*Discussion*

## Verification and Validation of a Computational Fluid Dynamics (CFD) Model for Air Entrainment at Spillway Aerators

By M. Cihan AYDIN and Mualla OZTURK, *Canadian Journal of Civil Engineering* 2009, 36, 826-838.

Fig. 1 - Sketch of spillway bottom aeration device and main flow regions

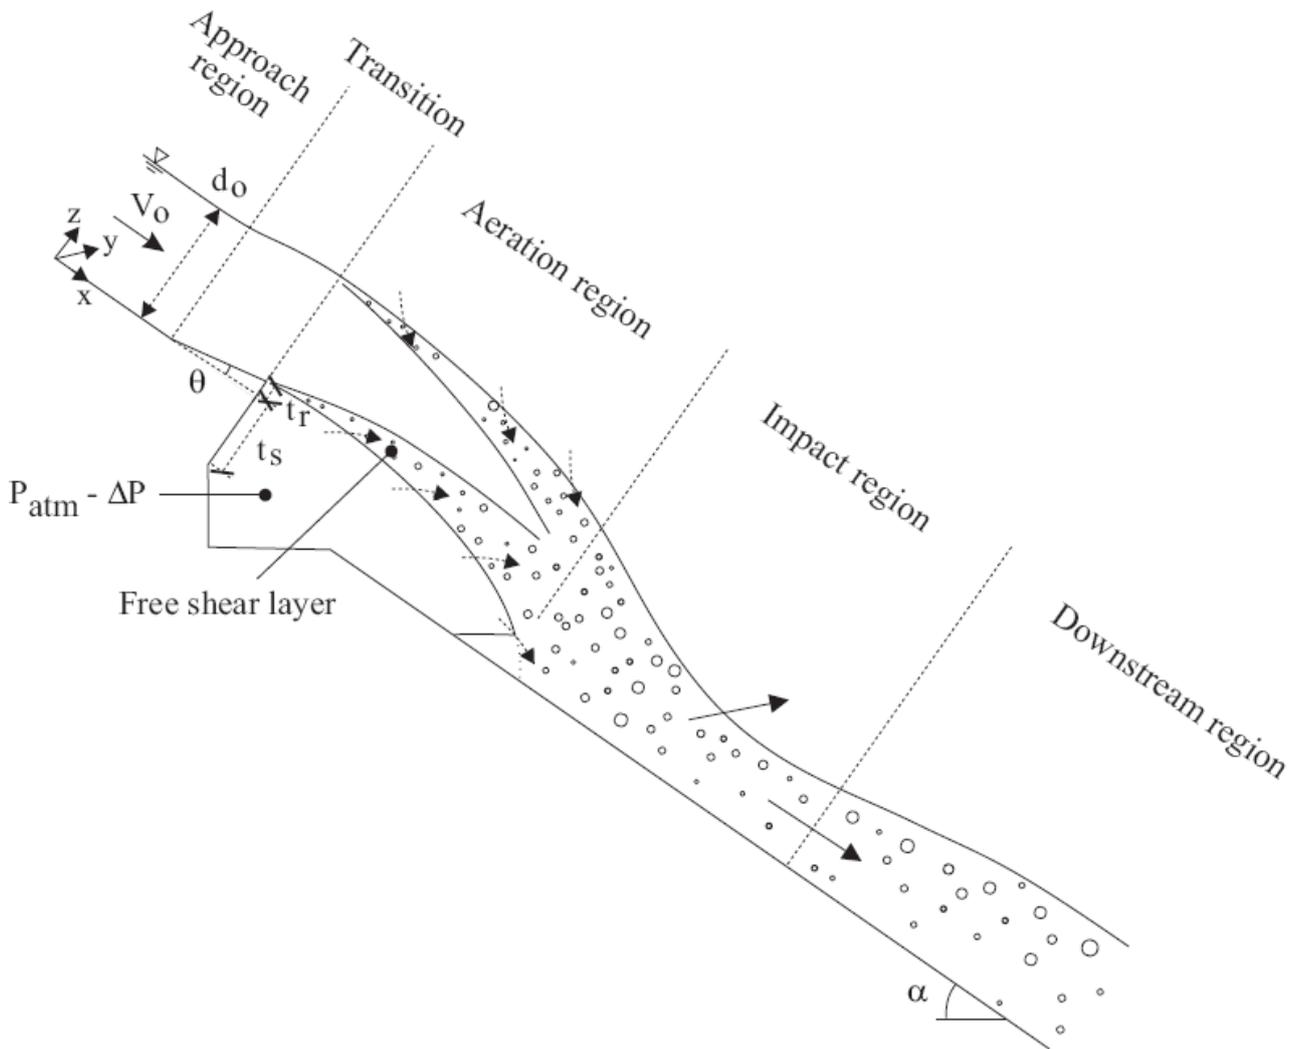
The best practice for the design of spillway aerators is based upon some solid physical modelling associated with some relevant mathematical modelling (Volkart et al. 1986, Wood 1985,1991). A physical model study must be performed under controlled flow conditions with geometrically similar models. In a dimensional analysis, the relevant parameters include the fluid properties and physical constants, the channel geometry and inflow conditions, the air-water flow properties including the entrained air bubble characteristics and turbulence characteristics. Considering a spillway aerator (Fig. 1), a simplified dimensional analysis shows that the parameters affecting the air-water flow properties at a position (x, y, z) are: (a) the fluid properties including the air and water densities  $\rho_{\text{air}}$  and  $\rho_{\text{w}}$ , the air and water dynamic viscosities  $\mu_{\text{air}}$  and  $\mu_{\text{w}}$ , the surface tension  $\sigma$ , and the gravity acceleration g, (b) the channel properties including the width B, chute slope  $\alpha$ , aerator ramp angle  $\theta$  and height  $t_r$  and offset  $t_s$ , (c) the inflow properties such as the inflow depth  $d_o$ , the inflow velocity  $V_o$ , a characteristic turbulent velocity  $u'_o$ , and (d) the cavity subpressure  $\Delta P$  (Fig. 4) The dimensionless air-water flow properties may be expressed as :
